STAFF REPORT

FROM: Planner I **FILE NO:** DP-2023-16

SUBJECT: Design review of 'Phase 2' Apartment Residential Development on Town-Owned Property at 571 Shaw Road

Figure 2 - Site Plan

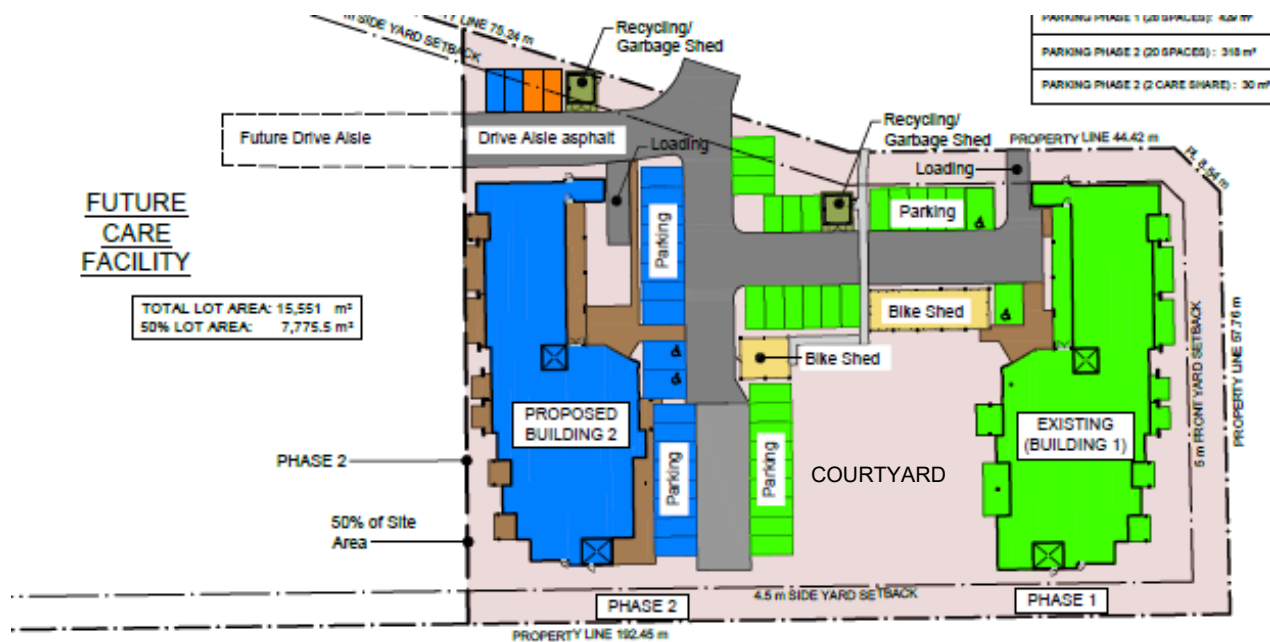
The future uses of the neighbouring site are noted as the phase 2 proposal under consideration proposes a 0.0 m setback from the divide between the use areas. This is illustrated in the site plan in Figure 1.

While there is no setback requirement in the zoning bylaw from a zoning divide, the BC Building Code will require a setback or alternate solution for the neighbouring development. Further, the residences of Building 2, with living areas and balconies oriented primarily to the west will require screening and privacy from any future community use proposed on the west portion of the property, which is not provided in the plan – rather relying on the forest presently adorning the undeveloped site.

A timeline for development of subarea 2 is unknown. In consideration of the proposal, Council may choose to require that the current development include a buffer to protect development potential for a future use on the subarea 2 site.
